**Road Infrastructure Design Report**  
**Proposed Residential Development**  
**Bridgegate, Mulladrillen and Rathgory,**  
**Drogheda Road, Ardee, Co. Louth**

Client: The Ardee Partnership

## ROAD INFRASTRUCTURE DESIGN REPORT

### PROPOSED RESIDENTIAL DEVELOPMENT, BRIDGEGATE, MULLADRILLEN AND RATHGORY, DROGHEDA ROAD, ARDEE, CO. LOUTH

*Drawing: ARDEE-CSC-00-XX-DR-C-1004*

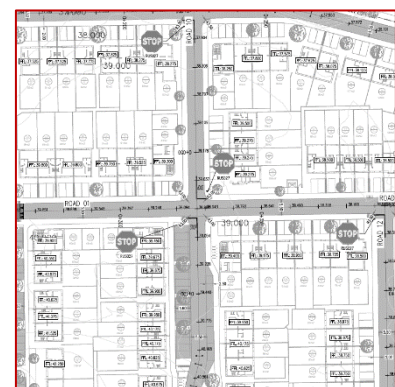
*Summary: The vertical and horizontal alignment may lead to excessive speeds and possible overshoot collisions at junctions.*

Drawing: ARDEE-CSC-00-XX-DR-C-1004

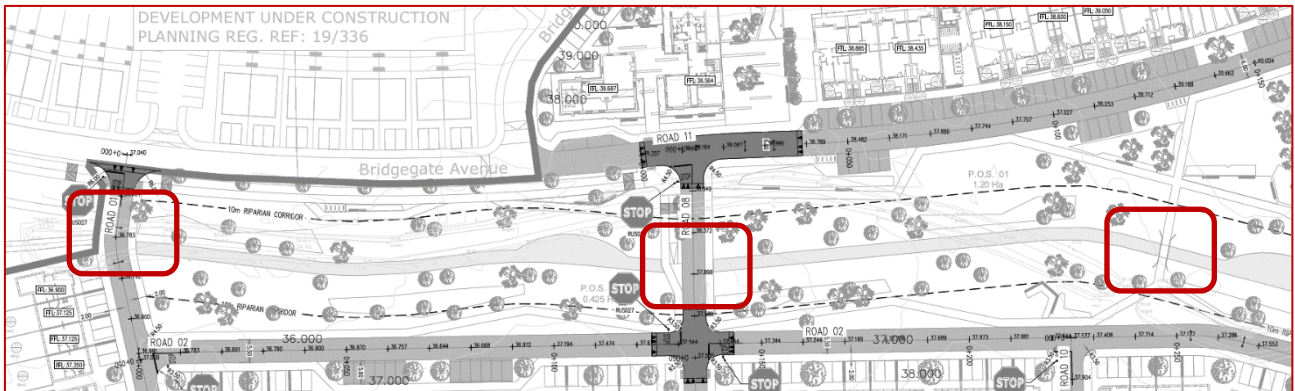
Summary: Edge protection has not been indicated at the three stream crossings. The absence of edge protection may increase the risk of road users falling from height, leading to personal injury.

The development crosses the riparian corridor at three locations (vehicle crossings on Road 1 and Road 8, and a pedestrian crossing opposite Road 10). At this early stage in the design process, edge protection has not been indicated at these locations. Insufficient edge protection at height hazards could increase the risk of road users falling from height, leading to personal injury, and possibly drowning when near a watercourse.

Provide edge protection at locations where height hazards exist.

Drawing: ARDEE-CSC-00-XX-DR-C-1004

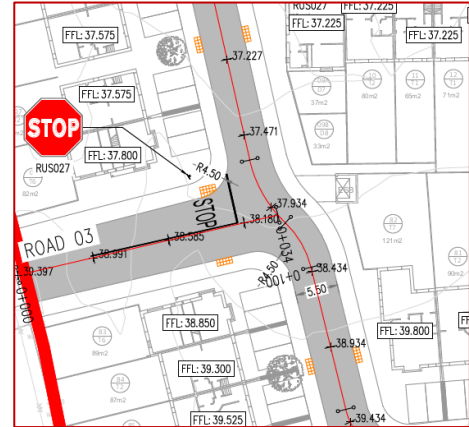
It is unclear if trees within the verges throughout the scheme will reduce or obstruct visibility for drivers exiting junctions and driveways. Should the location of trees reduce or block visibility, there is a risk of drivers exiting side roads and driveways when it is unsafe to do so ahead of oncoming vehicles, leading to side-on collisions. Additionally, the location of trees may block visibility to pedestrians attempting to cross which may result in a vehicle/pedestrian collisions.

Ensure sufficient visibility is available at all junctions, driveways, and pedestrian crossings within the proposed development.

Drawing: ARDEE-CSC-00-XX-DR-C-1004

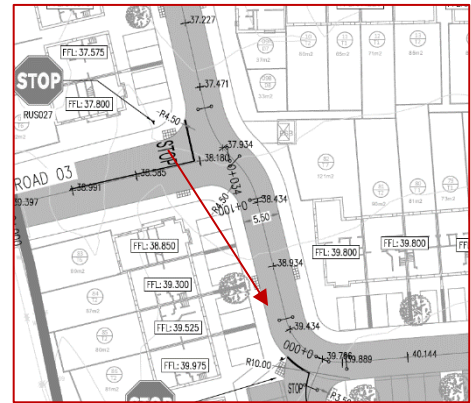
Summary: Failure to provide VRU facilities on all pedestrian desire lines may lead to slips, trips and falls.

The development proposes uncontrolled pedestrian crossing points (i.e. tactile paving) in certain locations, but not all pedestrian desire lines have been accommodated within the development. No facilities have been provided between the central public open space and the surrounding residential development, or between the public open space north and south of Bridgegate Avenue, or at the visitor parking on Bridgegate Avenue. Failure to provide an appropriate facility for non-motorised users at these expected desire line could result in unsafe crossings of the carriageway, leading to slips, trips, and falls.

A thorough review of likely pedestrian desire lines should be undertaken, and tactile paving/dropped kerbs provided to facilitate safe VRU movement.

Drawing: ARDEE-CSC-00-XX-DR-C-1004

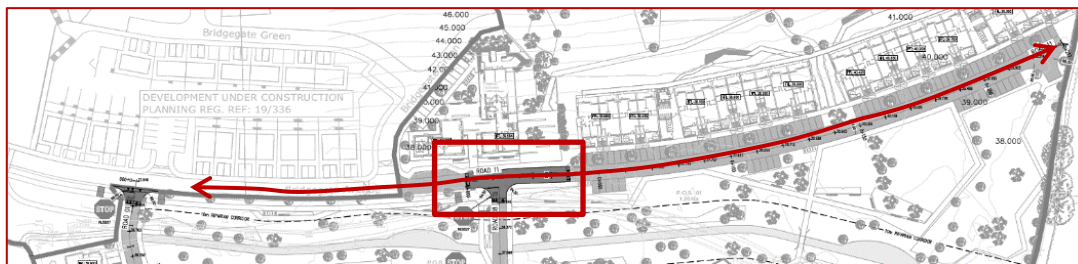
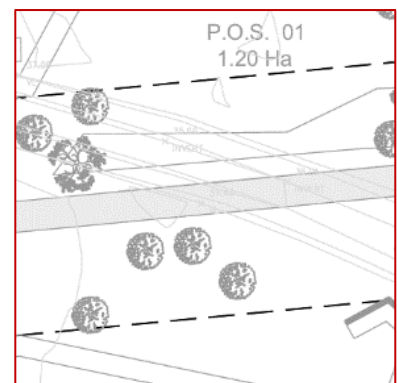
Summary: *The alignment of Bridgegate Avenue includes a subtle horizontal deflection that may lead to poor lane discipline and head-on collisions.*

The alignment of Bridgegate Avenue includes a subtle, and localised, horizontal deflection near its junction with Road 08, which may lead to inattentive drivers unintentionally crossing the centre line and striking oncoming vehicles.

The localised deflection should be removed, ensuring a smooth horizontal alignment is provided on Bridgegate Avenue.
